**Re: Benga Mining Ltd. – Grassy Mountain Coal Mine Project – *Coal Conservation Act* Application – Appendix 1C Addendum**

**Grassy Mountain Coal Mine Project**  
**Appendix 1C:**  
***Coal Conservation Act Application***  
**Addendum**

**October 2017**

<b>LEGEND</b>
 Modification to CCA Application
<b>PROJECT</b>  <b>RIVERSDALE RESOURCES</b>
<b>TITLE</b> <b>COARSE COAL CIRCUIT FLOWSHEET (Formerly C.2.6-7)</b>
<b>NOTES</b> RIVERSDALE RESOURCES, 2017

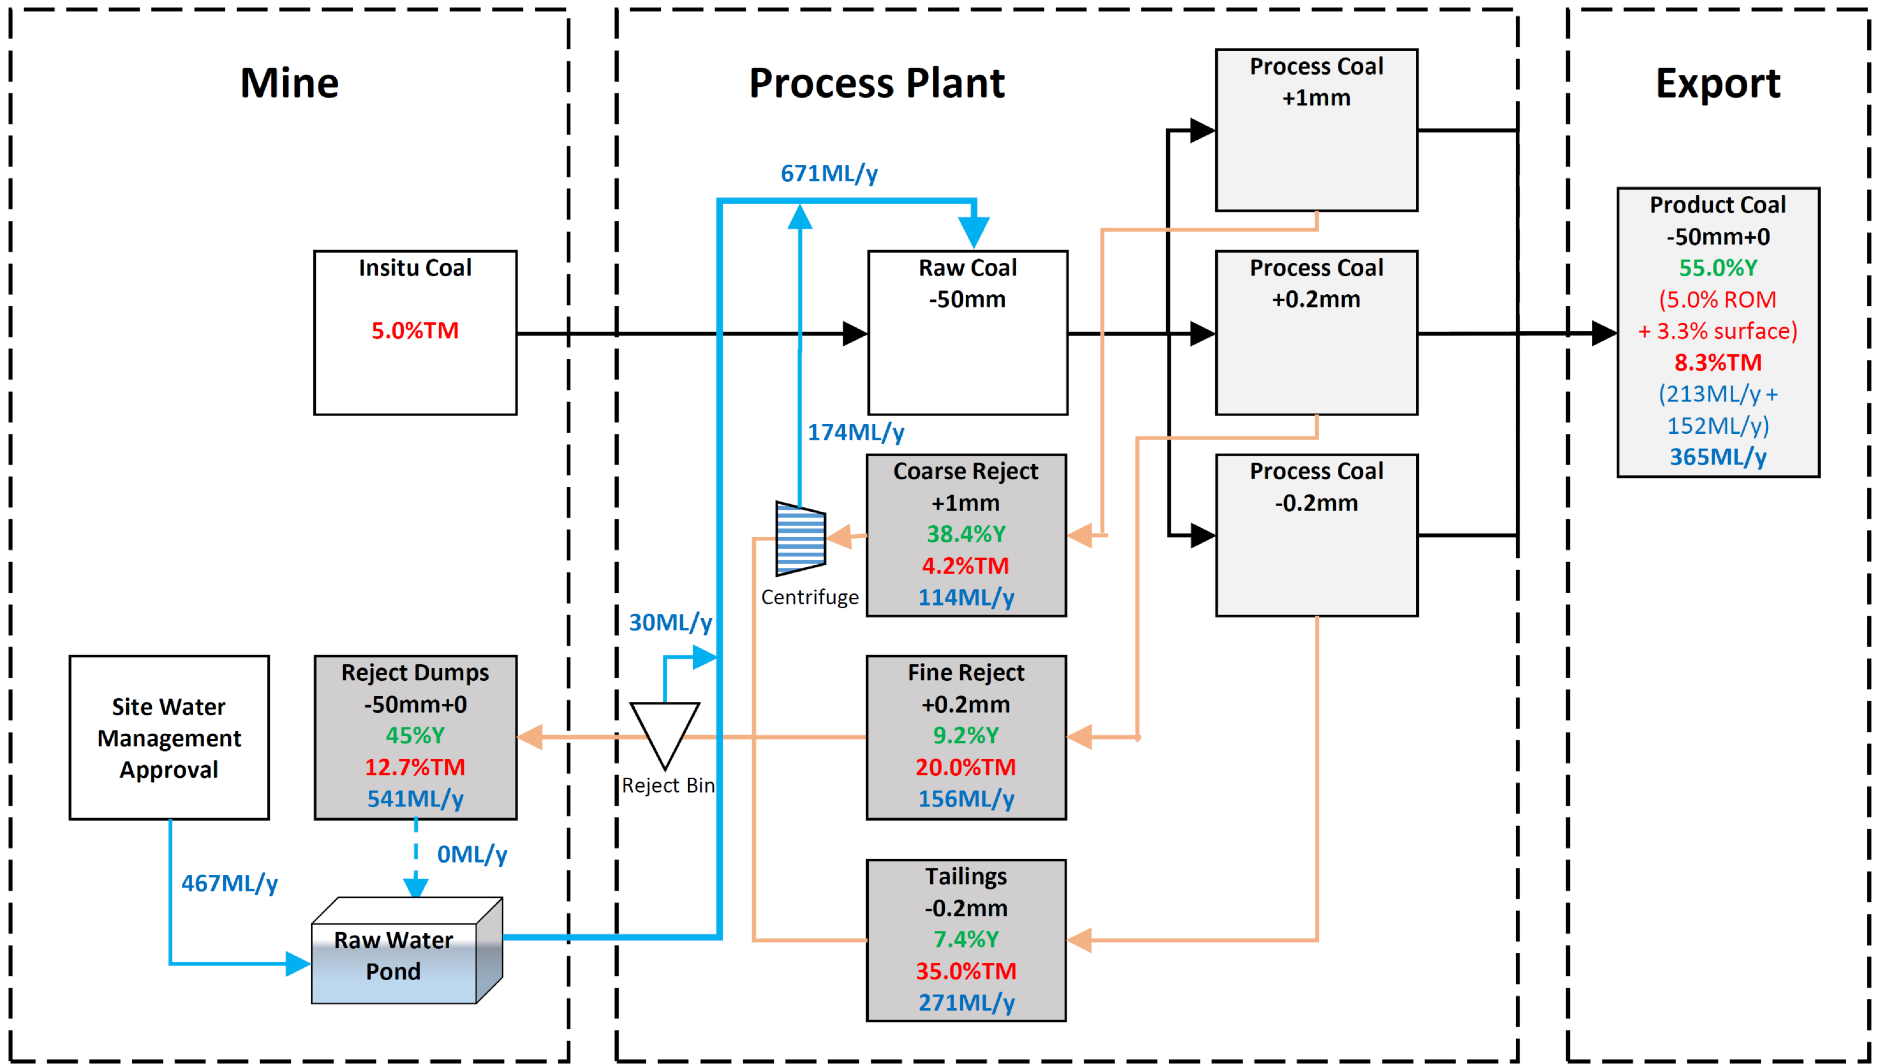
The deslime screen oversize coal fraction from each deslime screen will be processed through a dedicated dense medium circuit, *i.e.* the oversize of one deslime screen will report to one DMC feed sump which will report to one DMC and the oversize from the second deslime screen will report to

the second DMC feed sump which will report to the second DMC (Figure C.2.6-7). *This figure has been updated and is shown as Figure 2-3.*

*Coarse reject material from the reject drain and rinse screen section will report to one centrifuge for reject dewatering. The centrifuge will be a horizontal basket type and will discharge product directly onto the reject conveyor, CV-702.*

**PLANT WATER BALANCE (467ML/y) INCLUDING REJECT SIZING,  
AND COARSE REJECTS CENTRIFUGE**

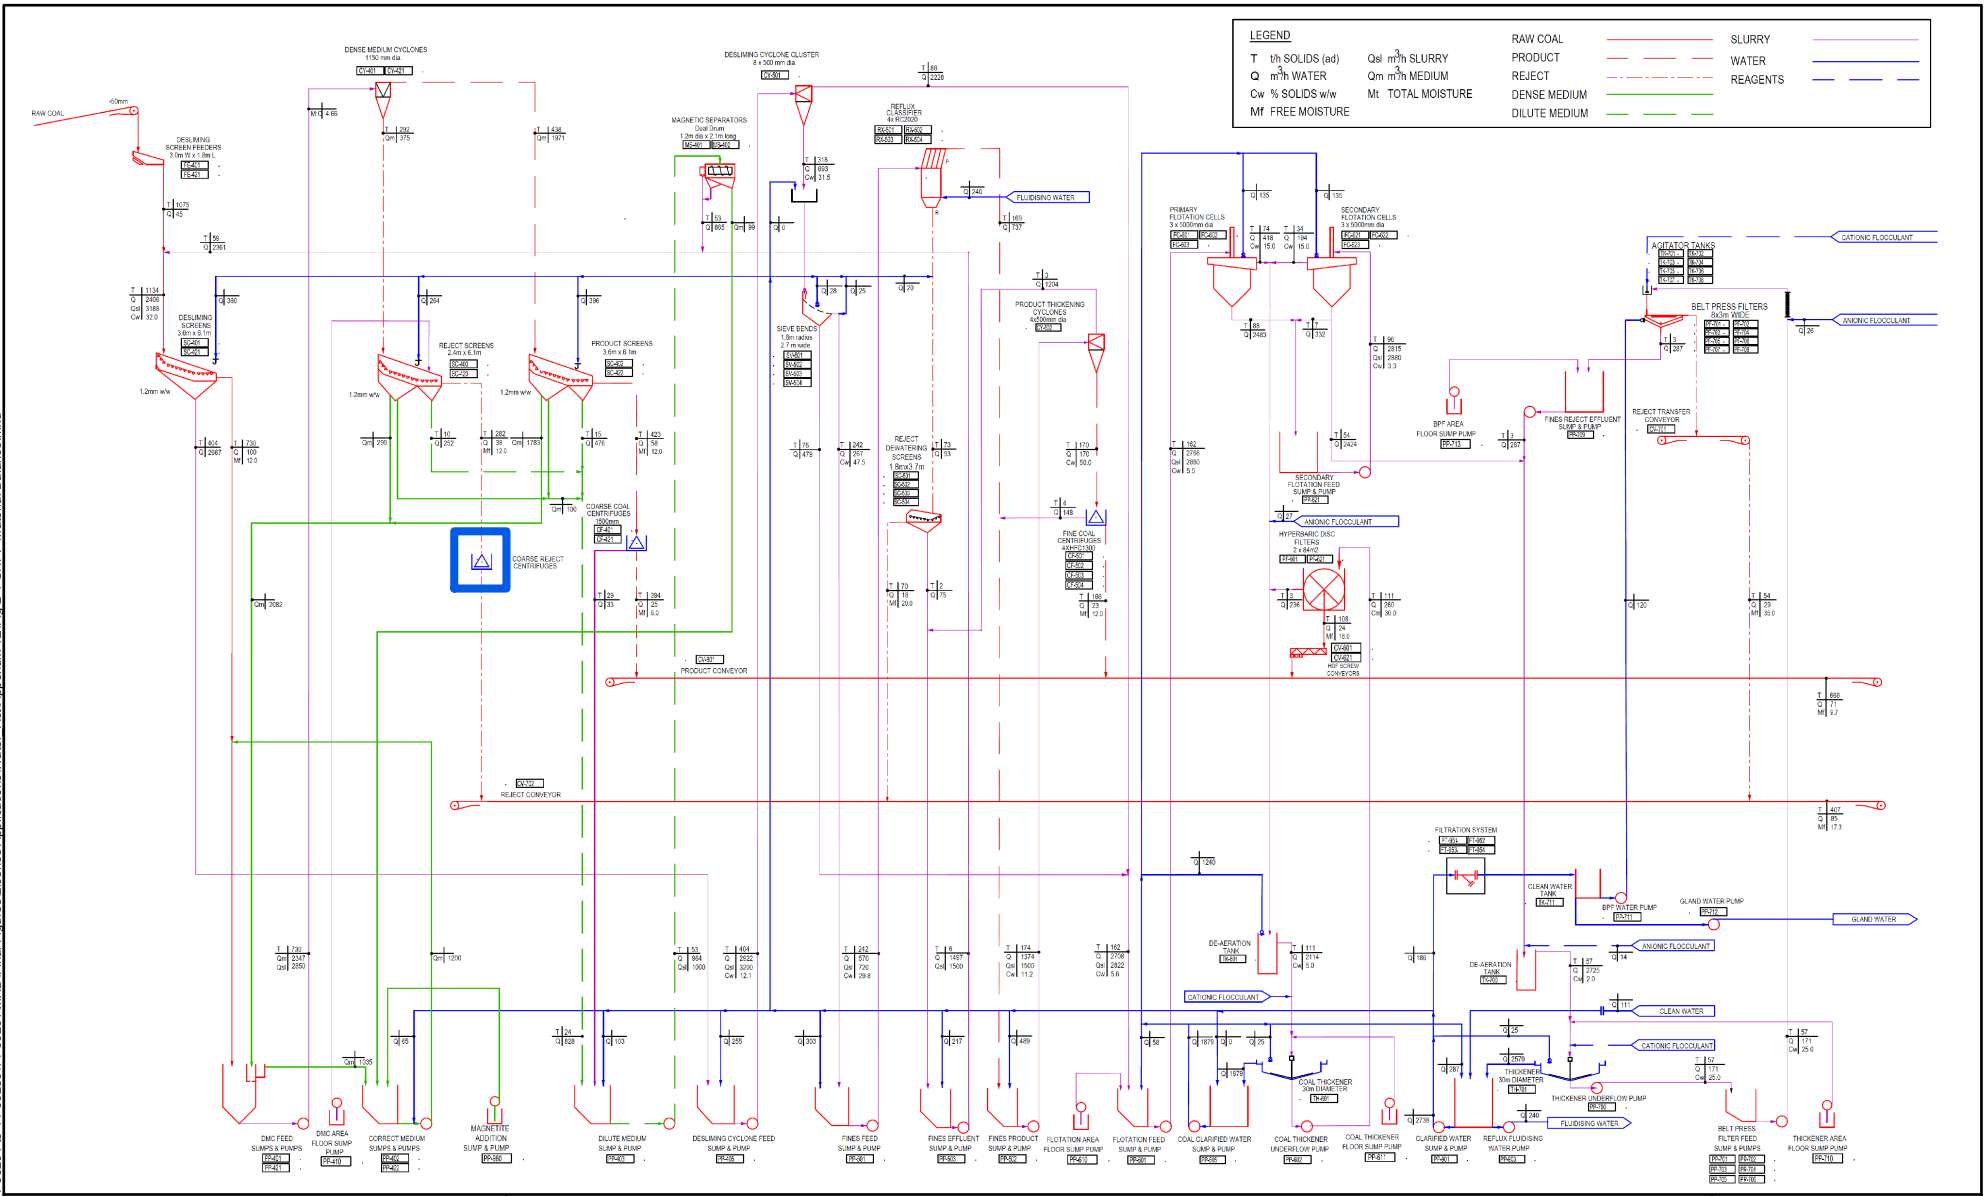
A plant water balance flow sheet has been included as **Figure 1-1 (was originally Figure C.2.5-1)** and an overall CPP Material balance has been included **as Figure 2-1 (was originally Figure C.2.5-2).**

PROJECT <b>RIVERSDALE</b> RESOURCES	<b>GRASSY MOUNTAIN COAL PROJECT</b>
TITLE <b>CPP BASIC FLOWSHEET (Formerly C.2.6-6)</b>	
NOTES RIVERSDALE RESOURCES, 2017	SCALE BAR: N/A

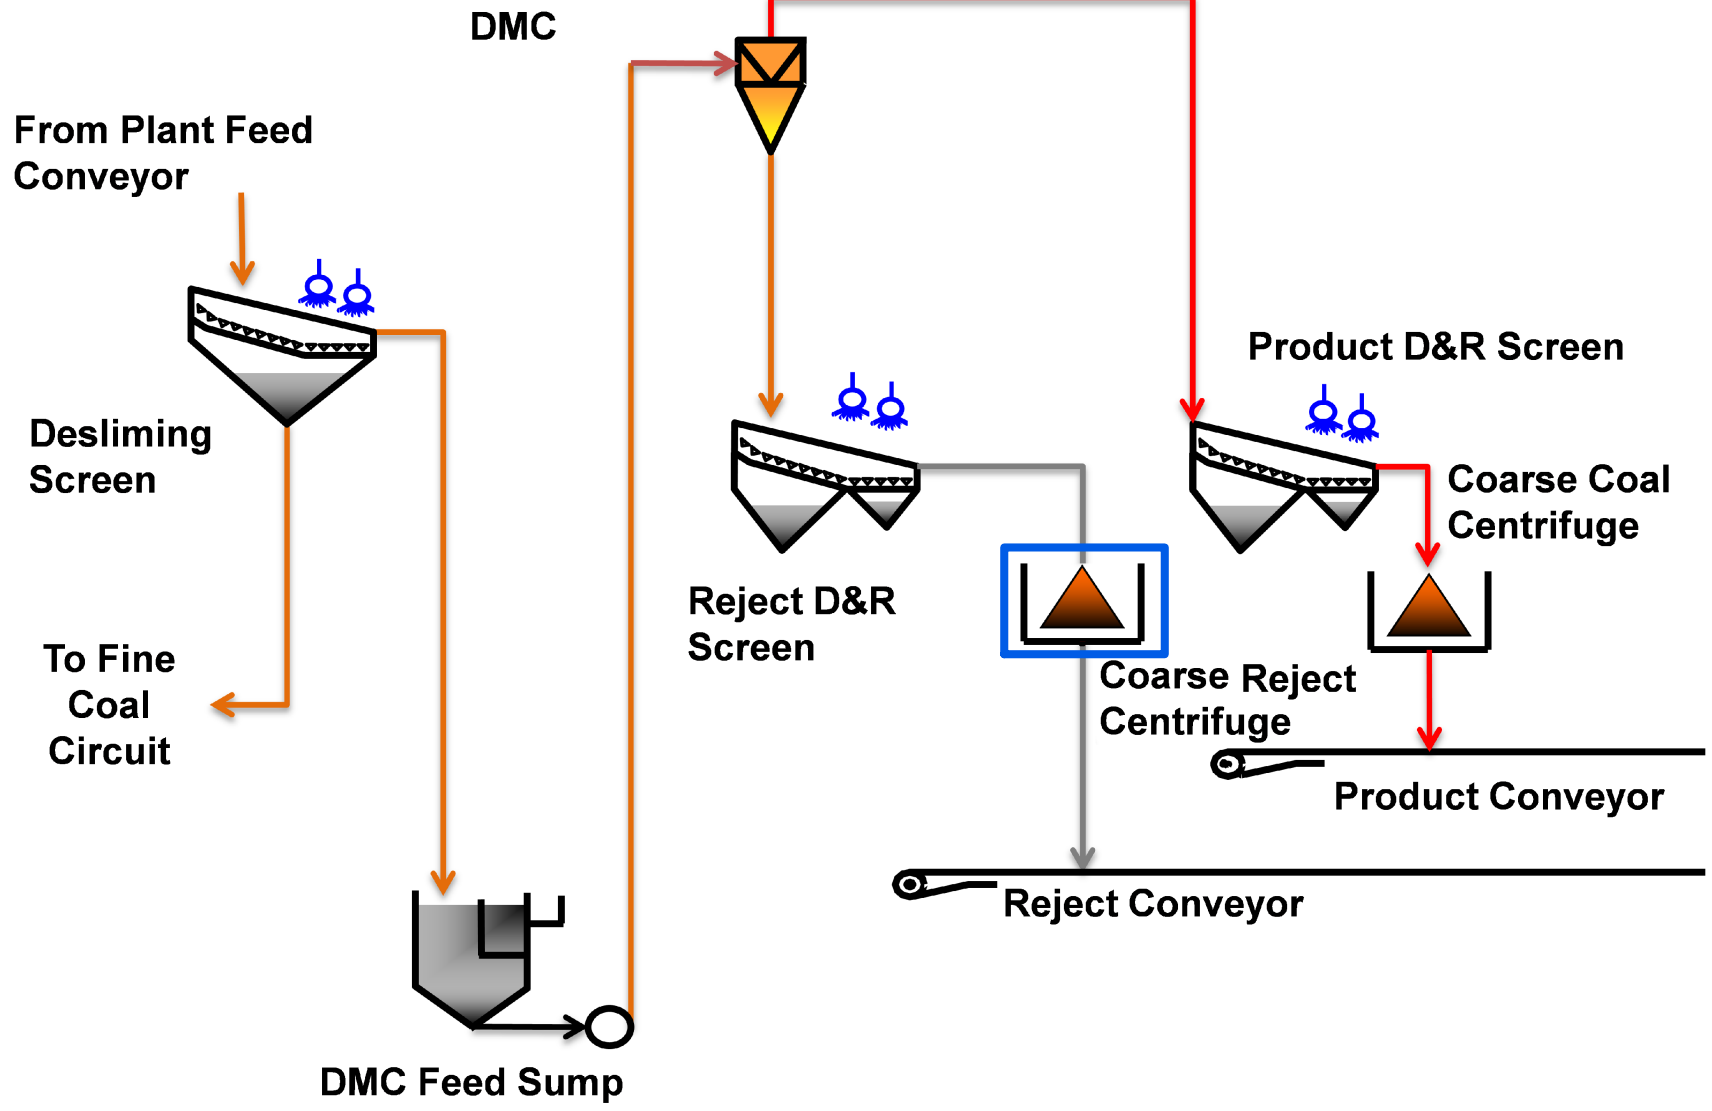
**Figure C.2.6-6** shows the wash plant basic flow diagram. **This figure has been updated and is shown as Figure 2-2.**
